Project	IEEE 802.16 Broadband Wireless Access Working Group < http://ieee802.org/16 >	
Title	AIs for Figures Consolidation	
Date Submitted	2007-09-07	
Source(s)	Wu Xuyong Huawei, Huawei Industry Base, Bantian, Longgang, Shenzhen, China 518129	Voice: +86-755-28976776 Fax: wuxuyong@huawei.com ,
Re:	IEEE 802.16-07/019: Task Group Review: Working Group Draft P802.16h/D2c (2007-08-13)	
Abstract	Several AIs taken by Xuyong to updating the figures according to meeting #50.	
Purpose	To consolidate the 16h draft.	
Notice	This document has been prepared to assist IEEE 802.16. It is offered as a basis for discussion and is not binding on the contributing individual(s) or organization(s). The material in this document is subject to change in form and content after further study. The contributor(s) reserve(s) the right to add, amend or withdraw material contained herein.	
Release	The contributor grants a free, irrevocable license to the IEEE to incorporate material contained in this contribution, and any modifications thereof, in the creation of an IEEE Standards publication; to copyright in the IEEE's name any IEEE Standards publication even though it may include portions of this contribution;

Figure h-58 CX-Frame structure for synchronized CXCBP

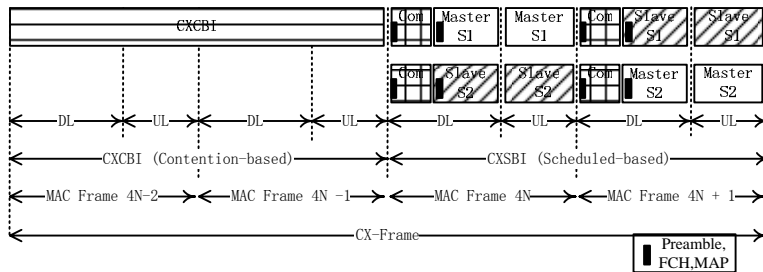
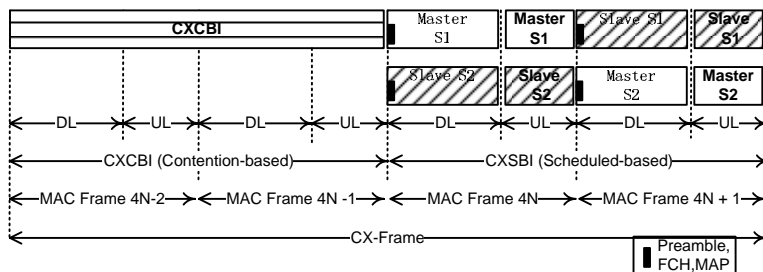
Comment 002: The TG had agreed that common subframe will be an option. So in order not to misleading the reader of the draft, we need to prevent showing the common subframe in the figures which do not have direct relationship with common subframe. The common subframe should appear only when we talk about it.

1) *The following figure and the related description have nothing to do with optional common, no necessity to mention common subframe here:*

Propose to update accordingly:

Figure h-59 Example of DL Scheduled Listen Before Talk opportunities inside the CXCW

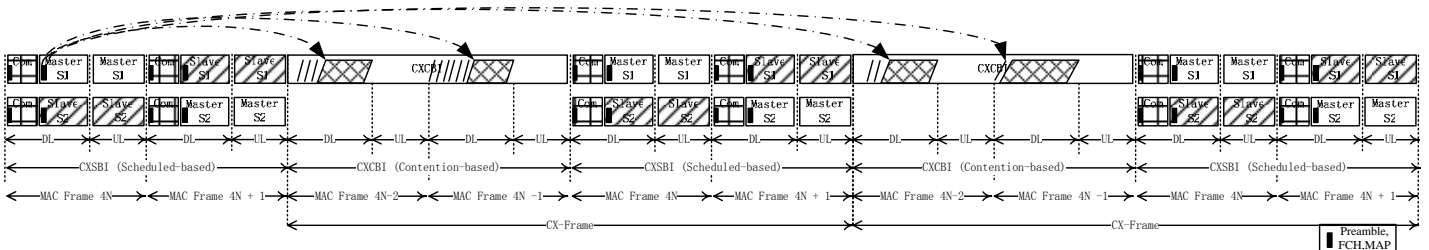
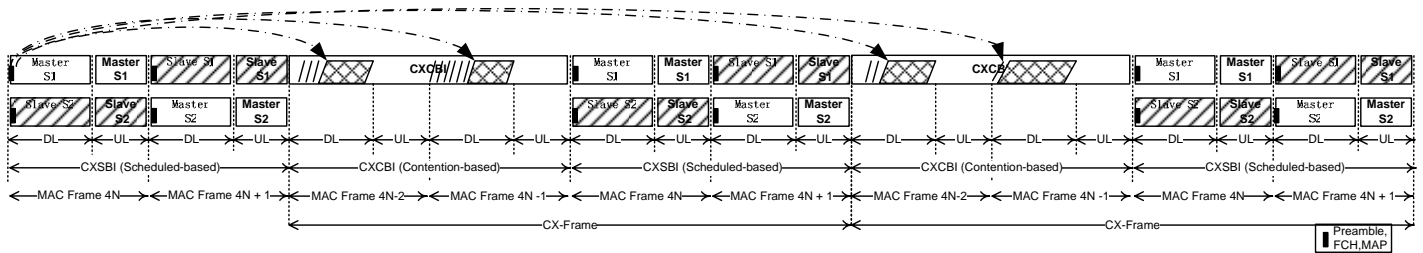
2) *For the same reason:*

These two figure should omit common subframe since there is no interconnection between optional common and this topic, if there is no other changing requirement, these 2 figure are proposed to be changed accordingly:

Figure h-64 Allocation of slots for BS and SS radio signature

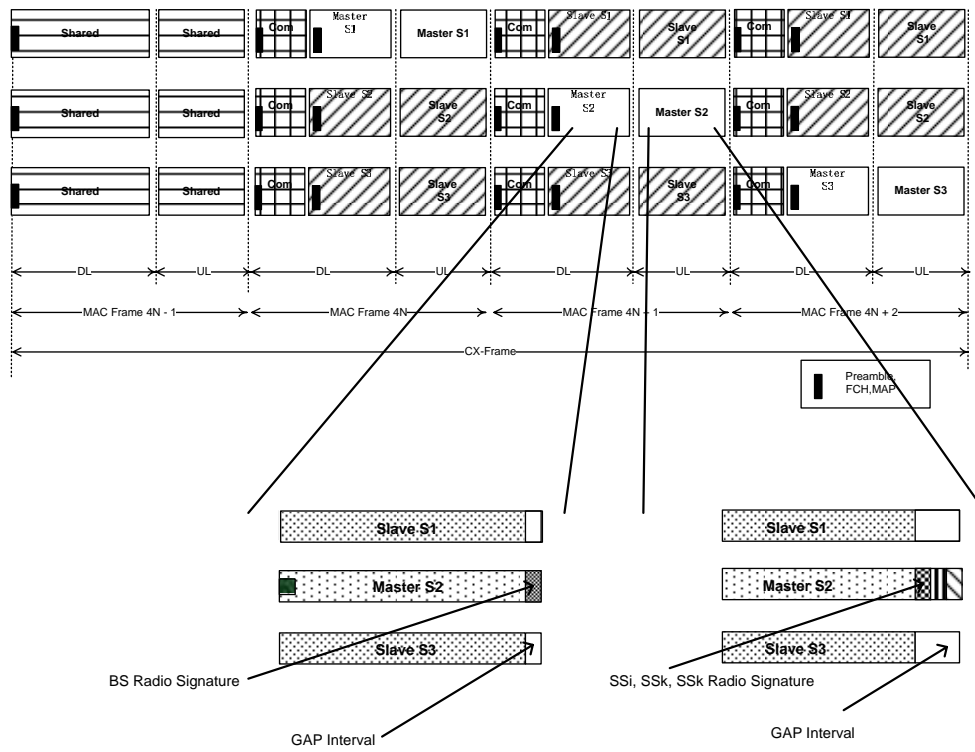
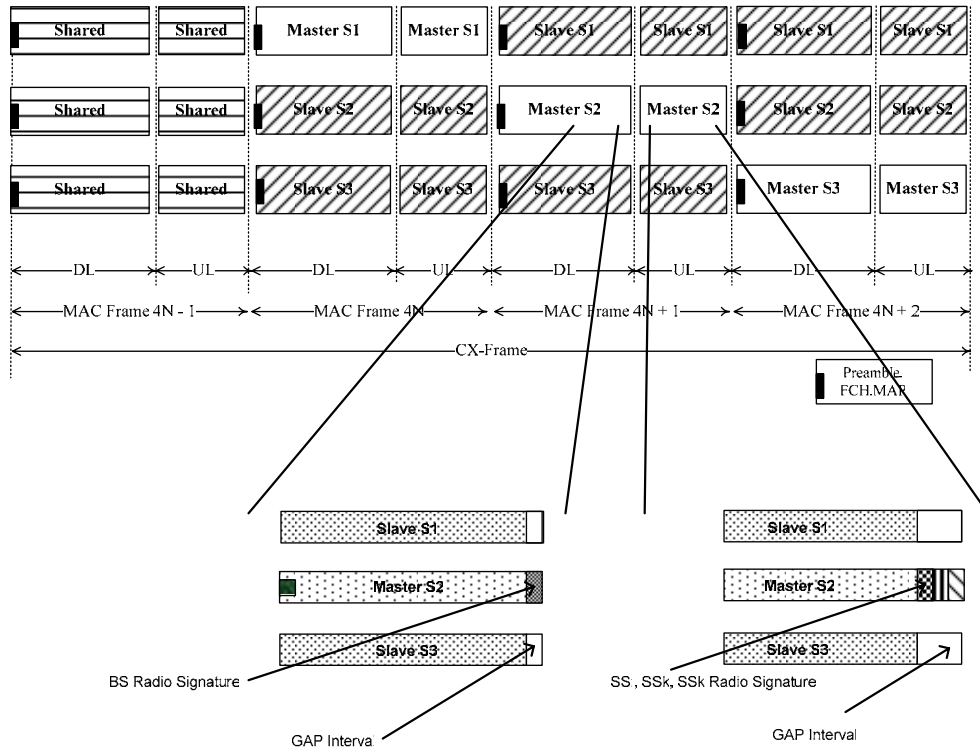
3) For the same reason:

Proposed to change into:

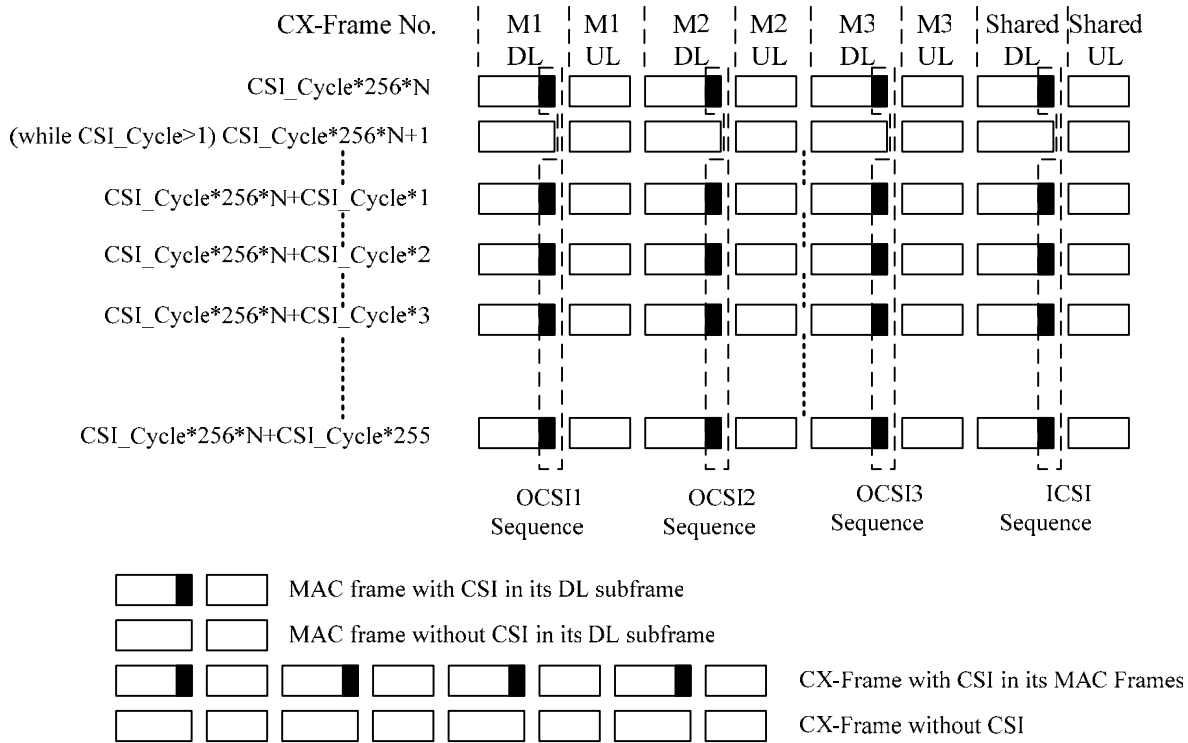
Description of CXCC with a Figure would be helpful to visualise the sub-channel mapping.

Provide Figure for CXCC sub-channels description.

4) For comment 067, the content in D2b section 15.1.5.3 has been moved into 15.3.1, we can have a figure to show the CXCC sub-channels in 15.3.1.1(with figure title “CXCC sub-channel 1-4 allocation”):

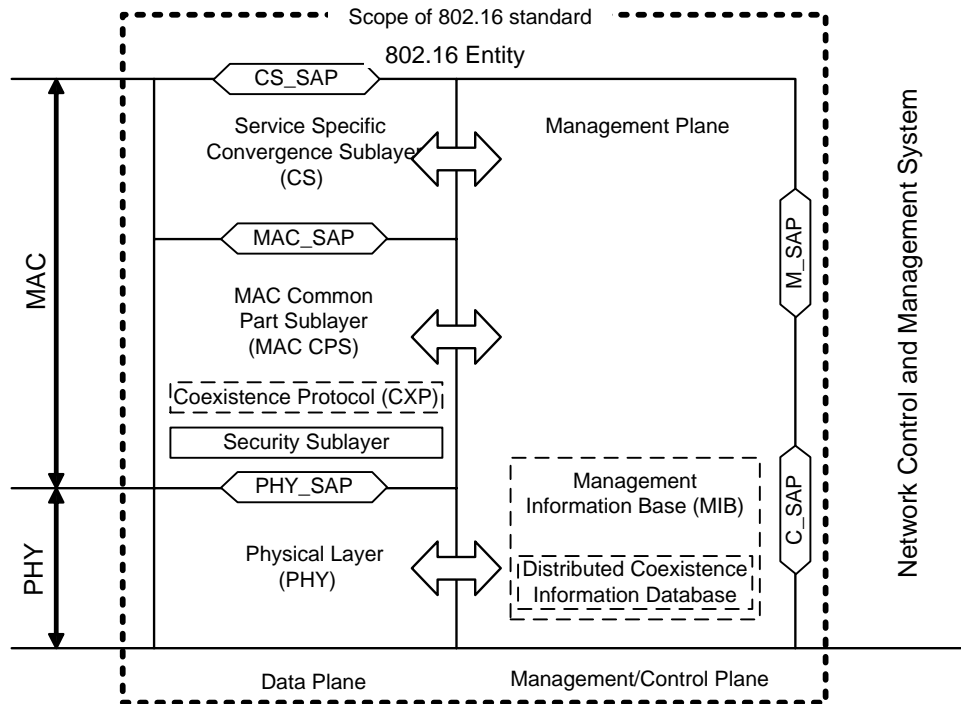
Figure h28 was supposed to be combined with the similar picture from 802.16f and put back in section 1 where it belongs.

Combine with the same Figure from 802.16f and move to the appropriate section 1 subsection.

5) For comment 072, the figure h35 should be removed and the figure in section 1 may be modified accordingly:

However, the Radio Resource Management is a NCMS issue, and Distributed Coexistence Information Database should be part of the MIB, CXP should be treated as conditional part of MAC CPS, so the figure may modified as following:
